SIB 41 08 22

DELIVERY STOP: TRANSMISSION HEAT SHIELD

2023-11-02

This Service Information Bulletin (Revision 2) replaces SI B41 08 22 dated January 2023.

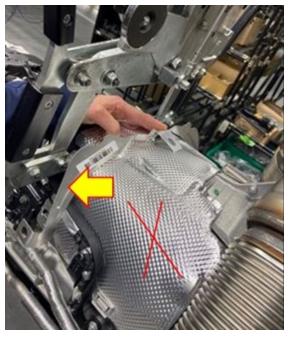
During assembly of the vehicle, a heat shield was mistakenly installed above the transmission.

Note: No heat shield should have been installed. It may contact other components in the narrow space along the bottom of the transmission tunnel.

- 2. Inspect transmission for the heat shield (arrow).
 - No heat shield observed: No further repairs needed. Reassembly the vehicle.
 - Heat shield is present: Continue to step 3.

Note: The corrugated aluminum cover (marked with the RED X) is not the component to check for; the one at the arrow is.

- 3. Remove the transmission following the repair instructions listed in AIR or ISTA 24 00 240 "Removing and installing automatic transmission".
 - Closely inspect any electrical harnesses or fluid-carrying lines which are fastened to the underside of the transmission tunnel for damage, which may have contacted the heat shield.
 - If any damage is observed, replace the component.
- 4. Remove and discard the heat shield.
- 5. Reassemble the vehicle.
